Product Change Notice (PCN)

- Product(s) Affected: PFB0812EE-E
- Reason(s) for Change: Change datasheet spec wire total length from 330+10/-0 to 330+/-10mm
- Duration of Change: Permanent
- Impact: Affected Date Code: from July 14, 2026 onward

Description of Change: Change wire length in data sheet

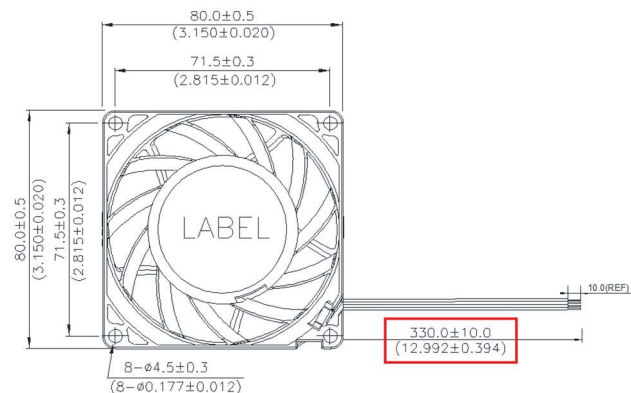
Change datasheet spec wire total length from 330+10/-0 to 330+/-10mm as picture below.

Before:

After:
